FINAL
MONITORING REPORT (MY1)

ALLIANCE HEADWATERS MITIGATION SITE

RS Response to DMS comments on Draft Yr. 1 (2020) Monitoring Report

APPENDIX F: RESPONSES TO MYO IRT COMMENTS

Figure 1. Site Location

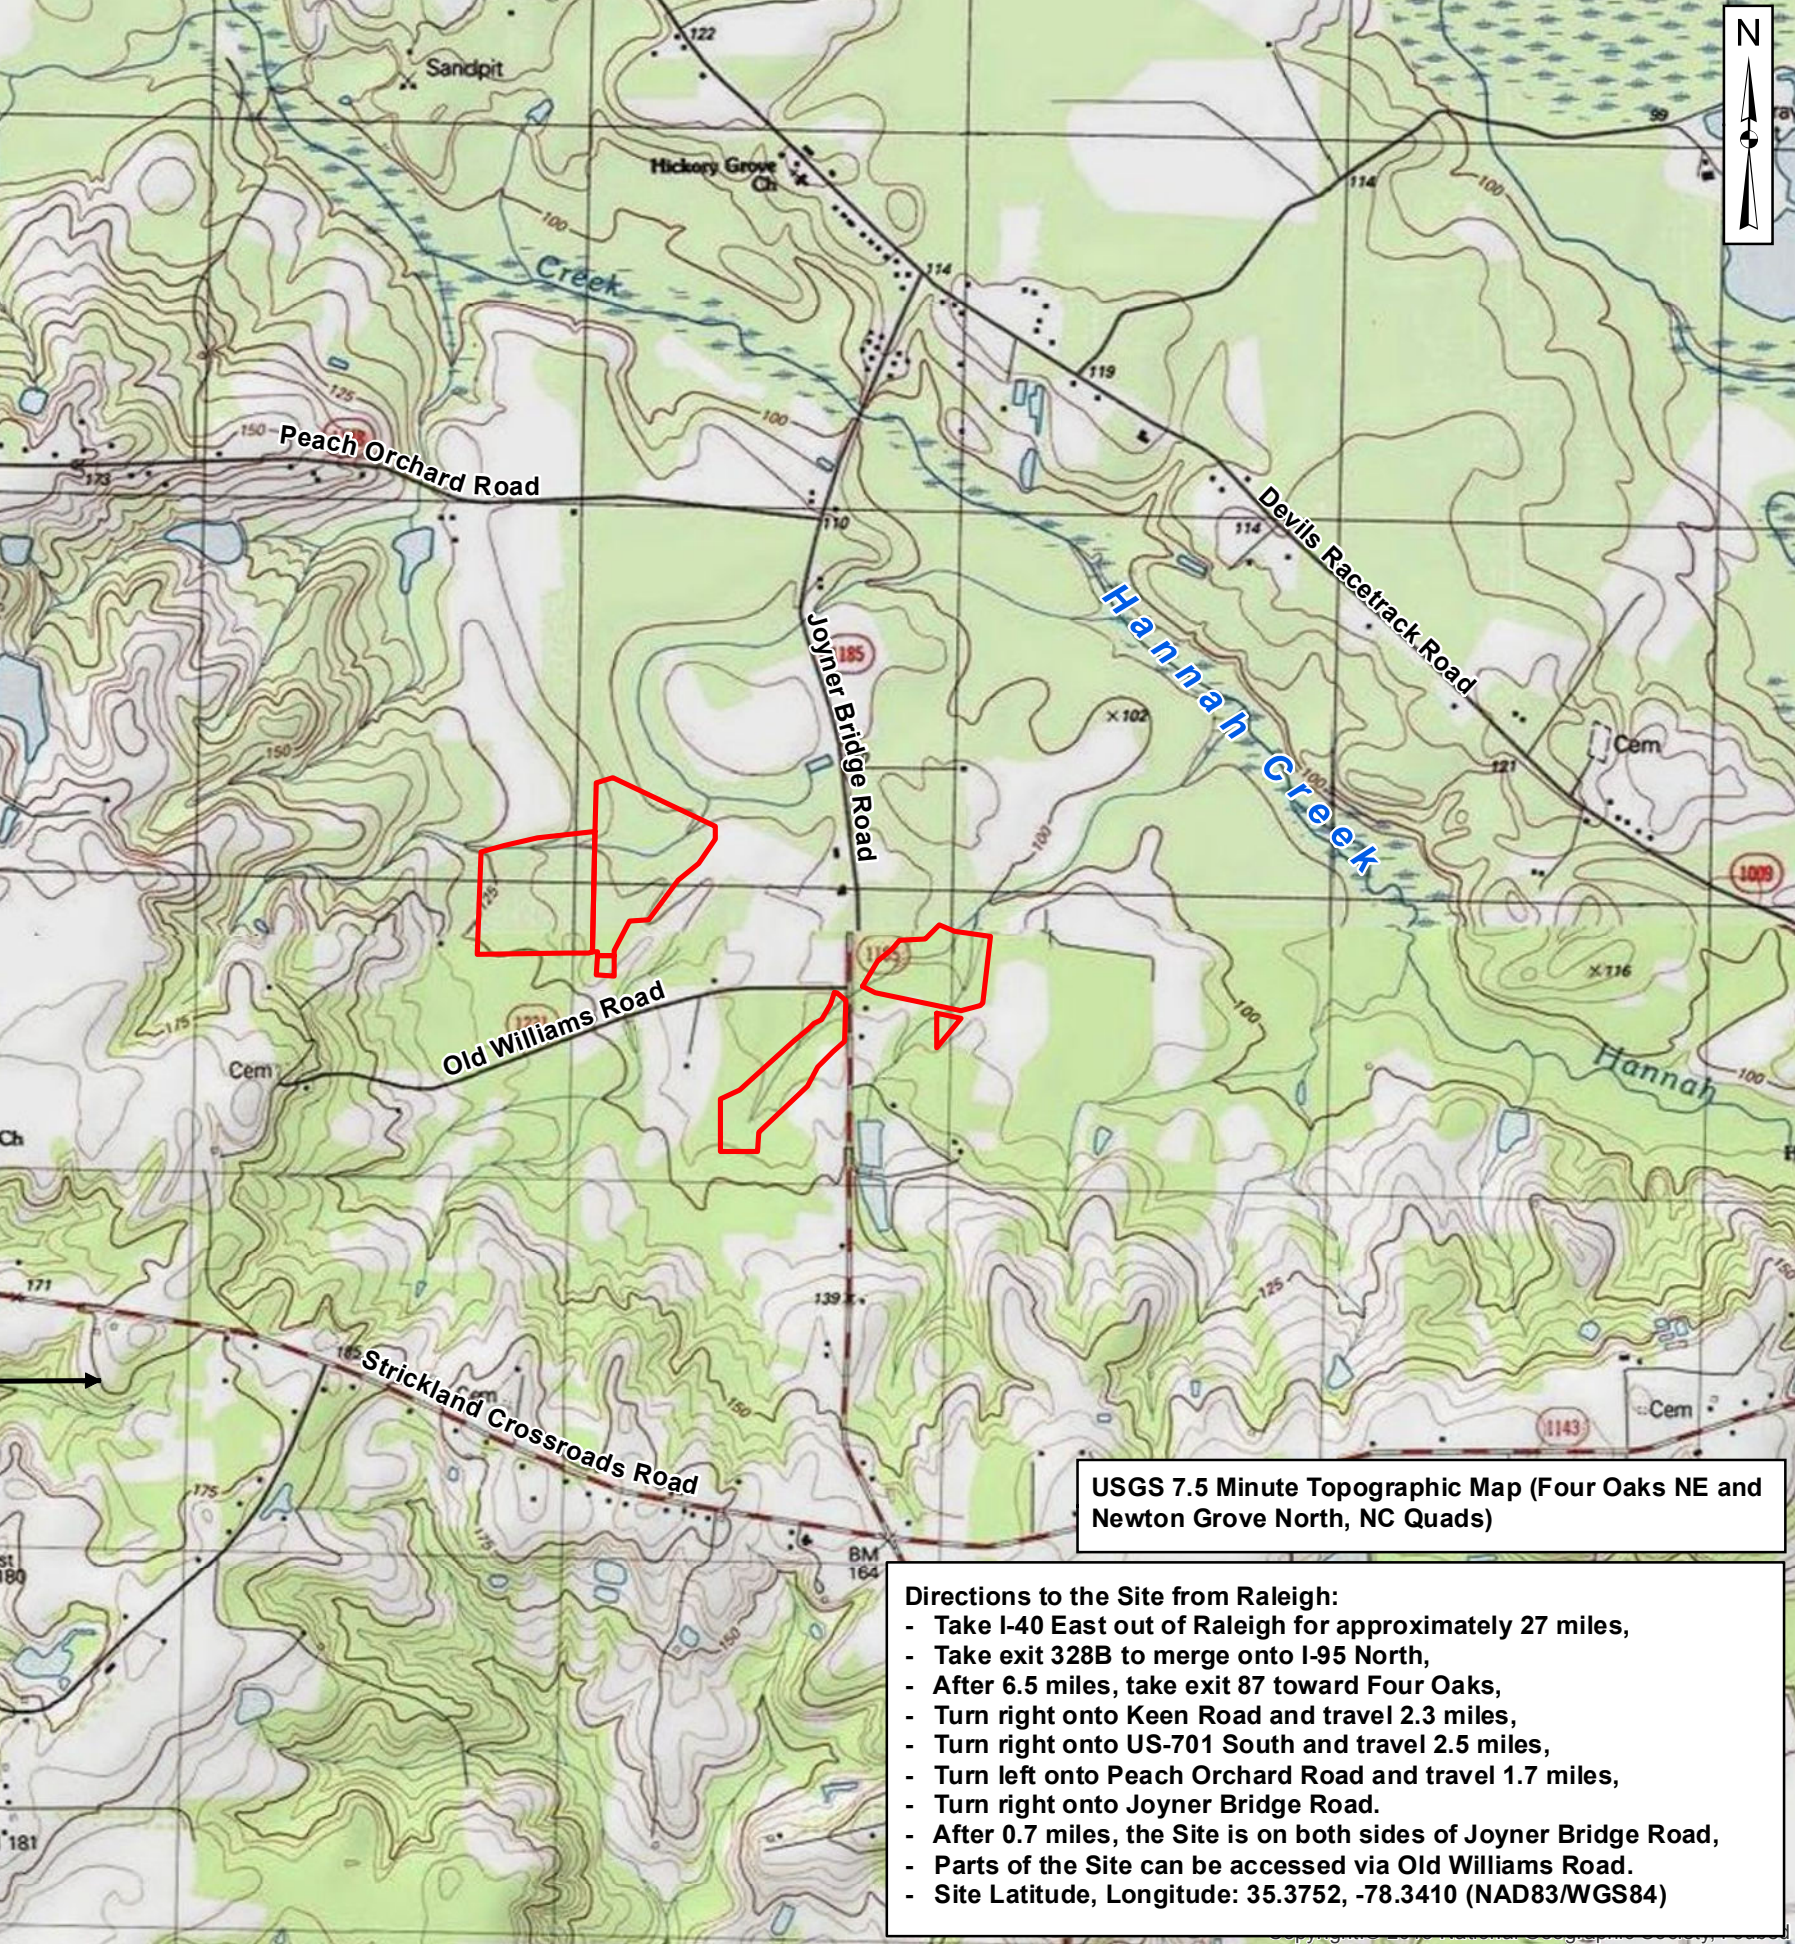
3. Figure 1 Project Name is erroneous.
The Figure 1 Project name was updated.
4. Figure 2A Wetland Restoration acreage is erroneous (Should be approximately 9.5 acres instead of 30.24)
DMS feels it is prudent to show the site-wide wetland acreage and stream footage on Figures 2A and 2B to avoid confusion with site assets.

2

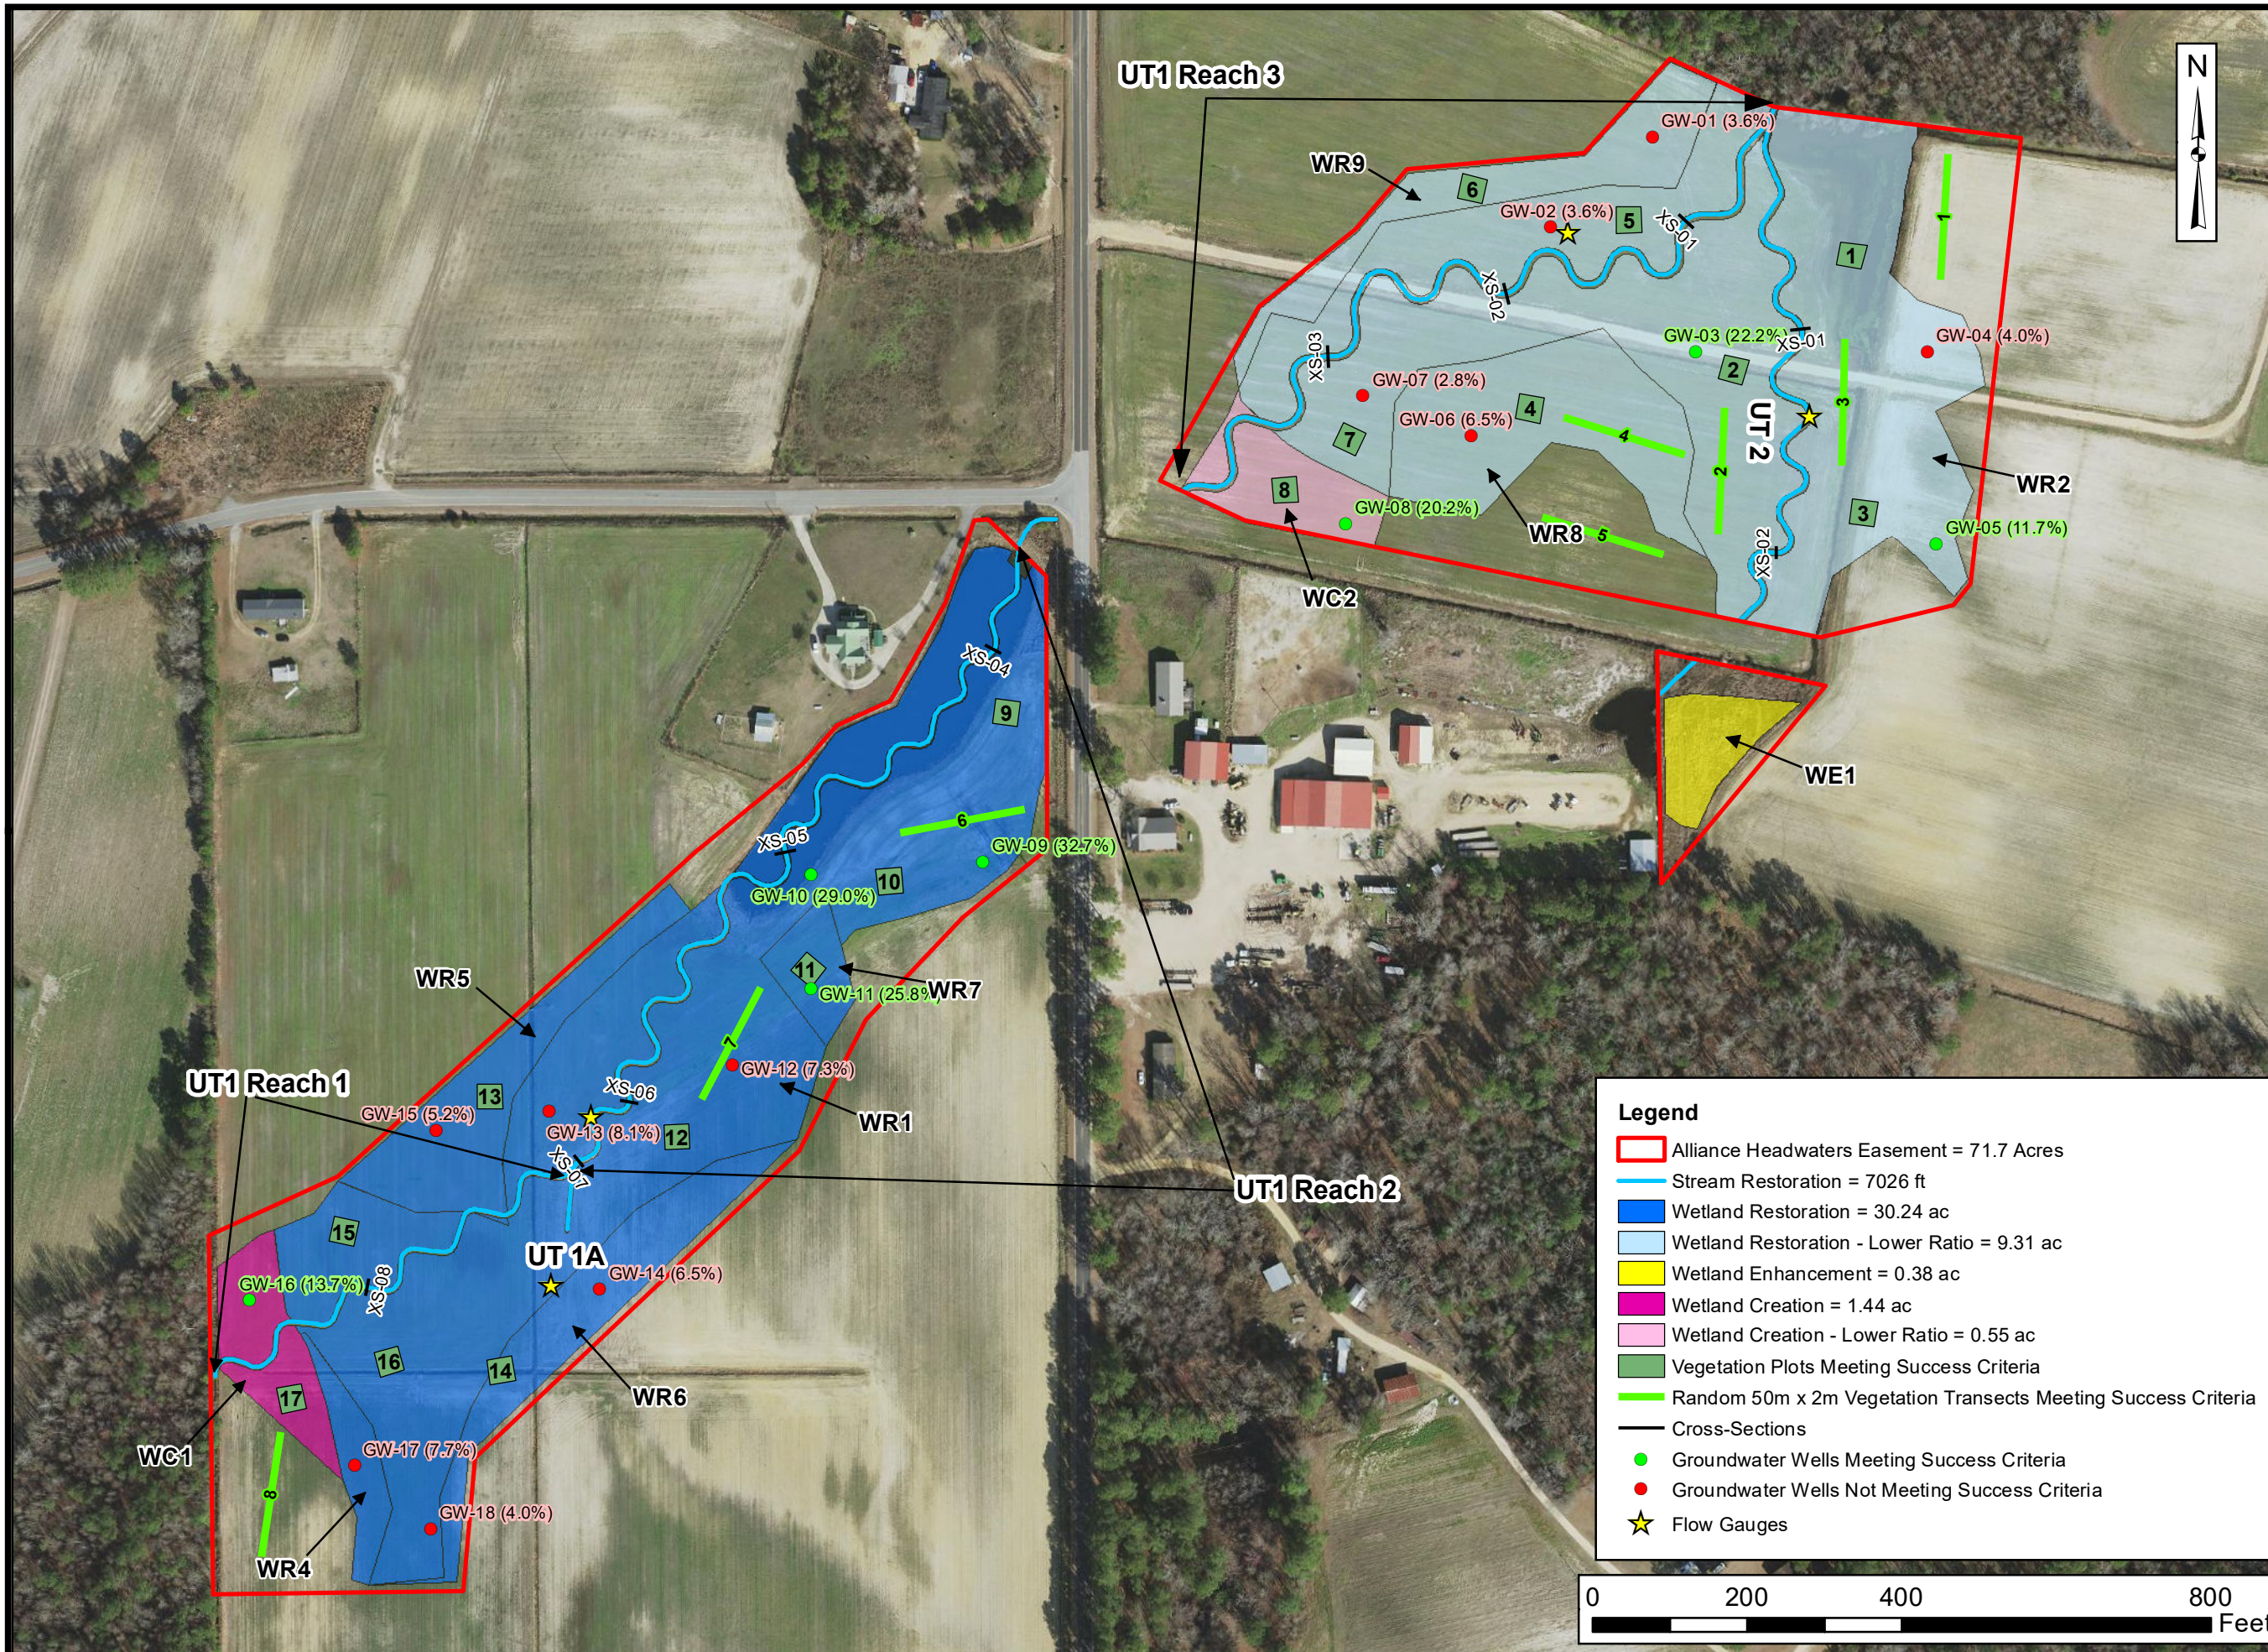
- CCPV. Please provide location of soil temp probe on legend and map per IRT request. It may also be beneficial to label hydroperiods on the gauges (add to attribute table and label) to show overall trends that may help in IRT discussions of gauge performance.
The soil temperature probe/rain gauge location was added to Figure 2. Additionally, hydroperiods for the groundwater gauges (in percent of growing season) were added to the labels on Figure 2.

FIGURE
2A

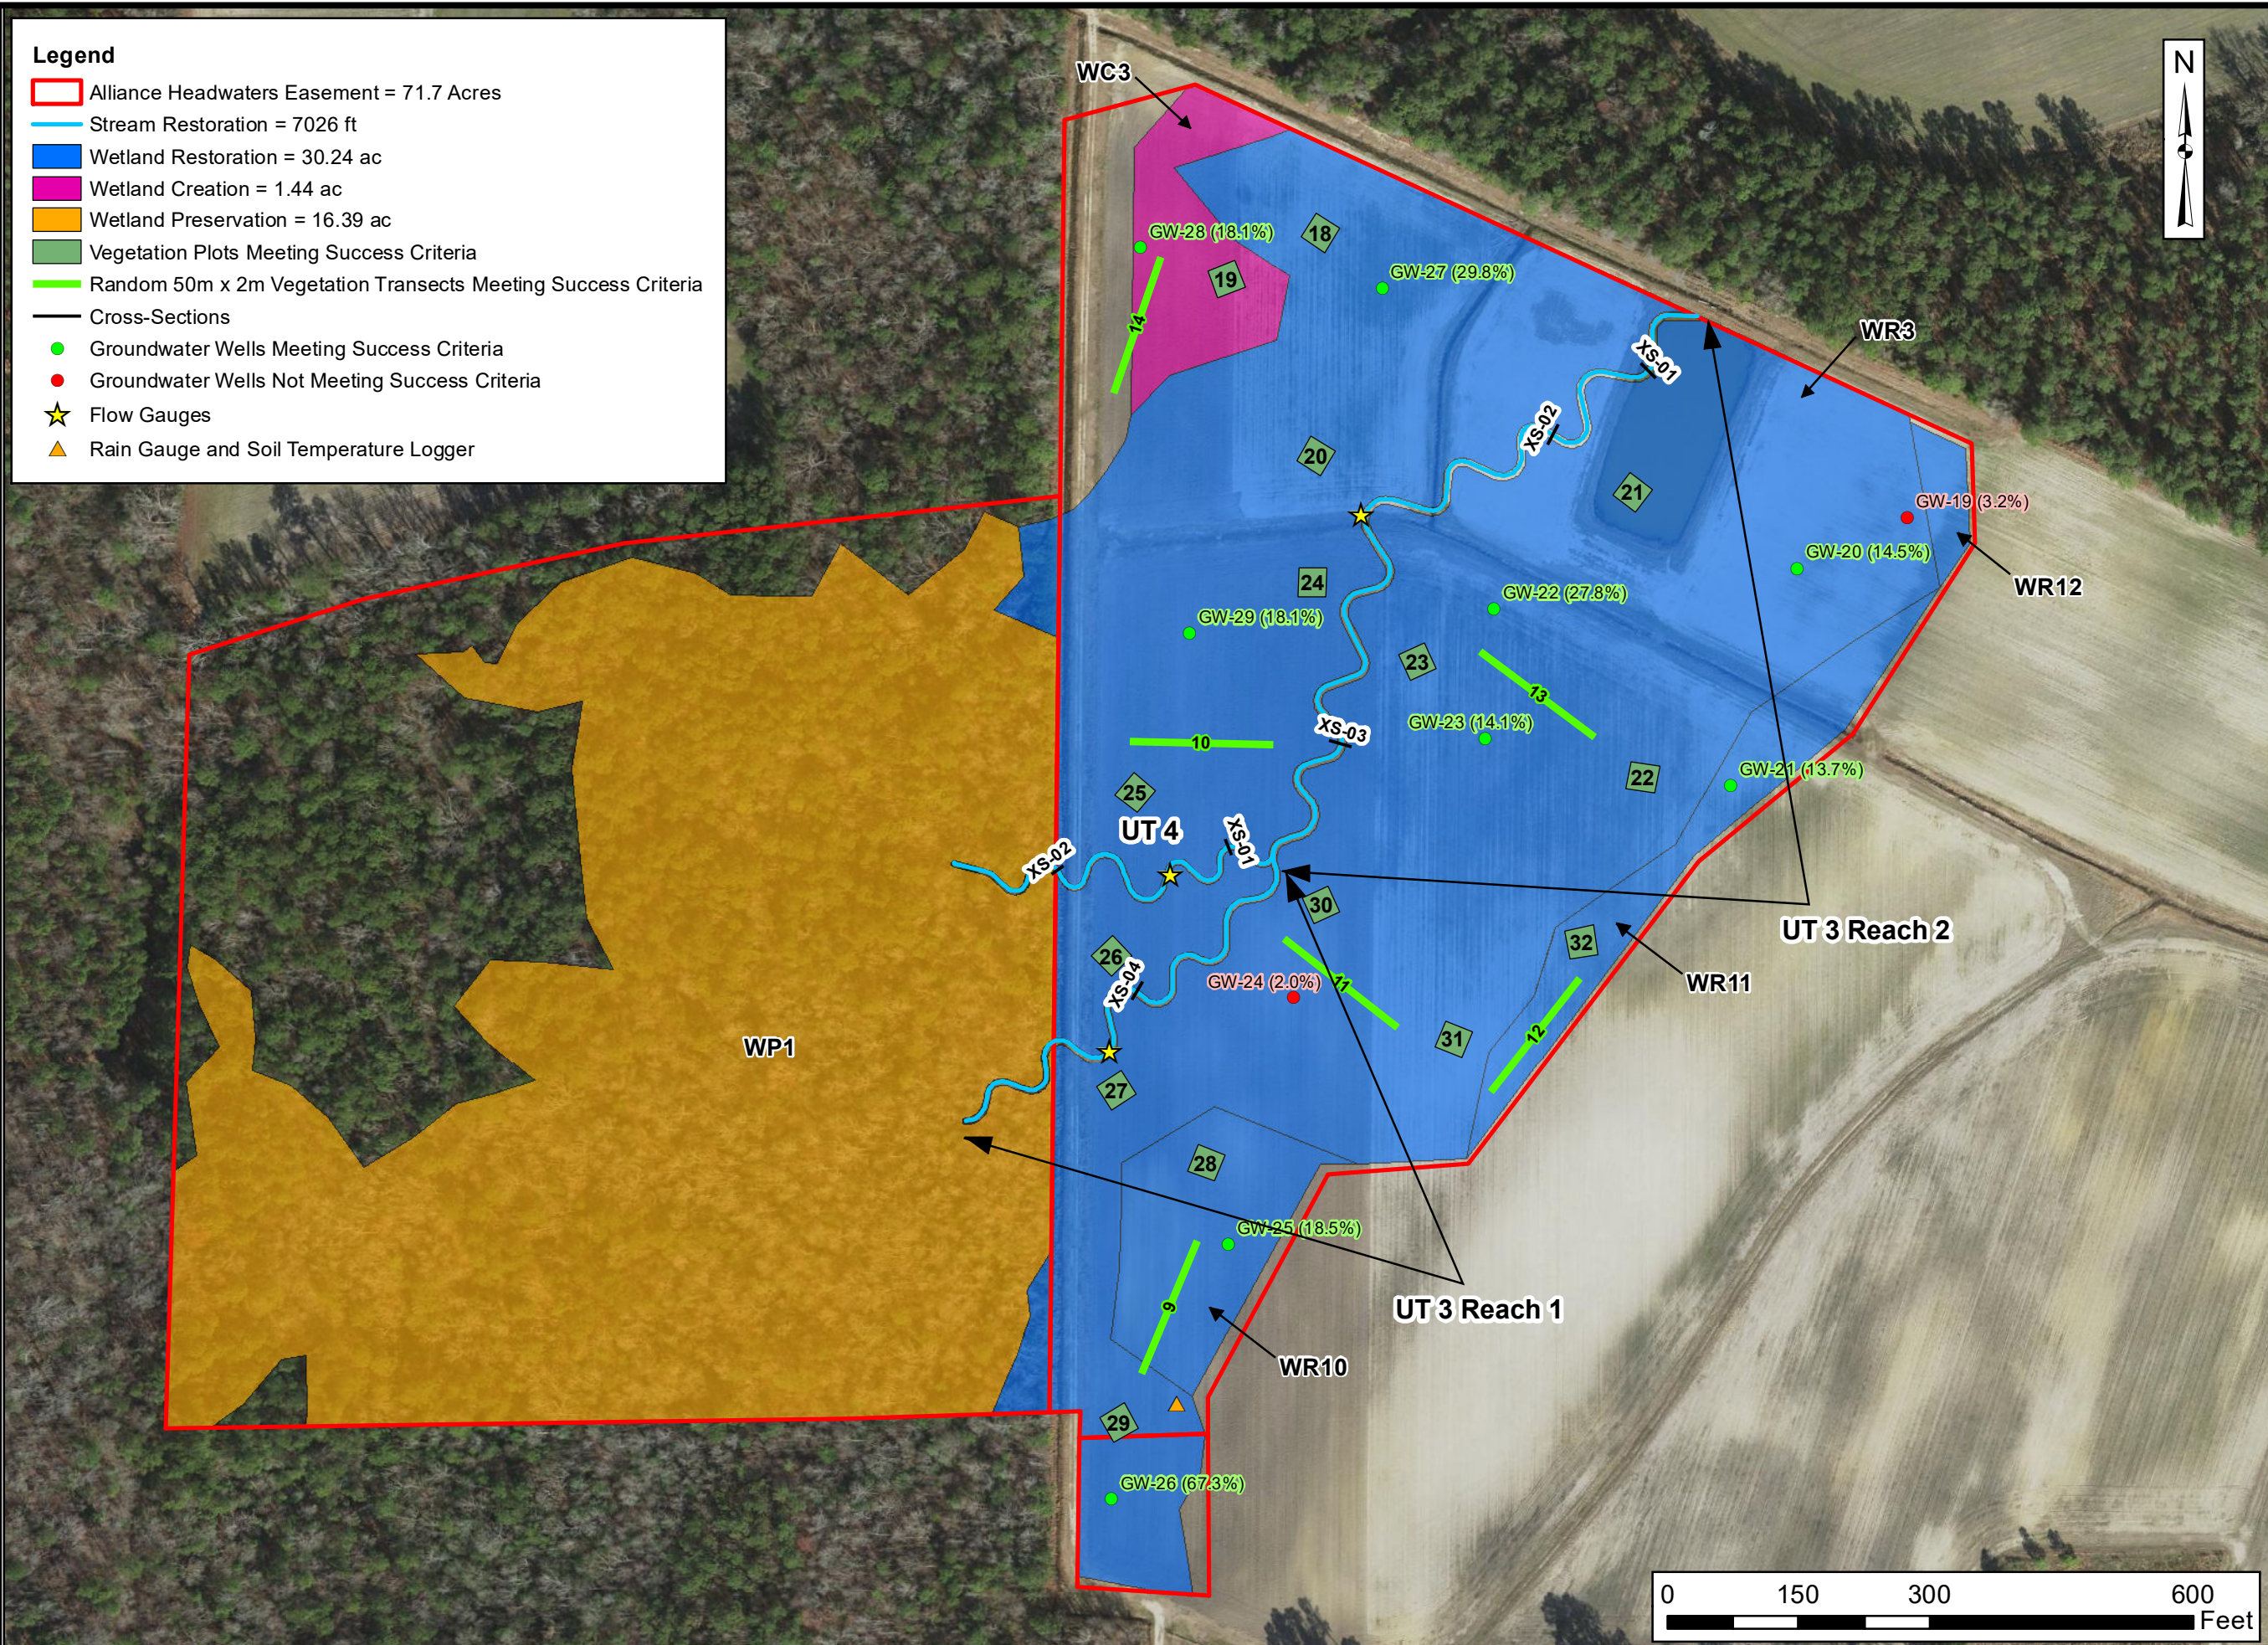
5. Figure 2A Wetland Creation (WC1) should be 0.54 acres instead of 1.44 acres
DMS feels it is prudent to show the site-wide wetland acreage and stream footage on Figures 2A and 2B to avoid confusion with site assets.

1. Please be sure to include the soil temperature probes on the CCPV for the monitoring reports.
The rain gauge and soil temperature probe were added to Figure 2A.
2. Will need to watch a few areas of wetland restoration given some of the grading, particularly upper UT1- R3, and other similar areas.
Understood
3. The drone footage was good. I would recommend next time to include the inset map for full flight after construction as well.
Understood
4. Some drone photos at the end of the document were good to see the tributaries coming out of the headwater wetland. Perhaps more of these in the future.
Additional photos were added to the Year 1 (2020) Monitoring Report. We will continue to supply photos with the annual monitoring report.
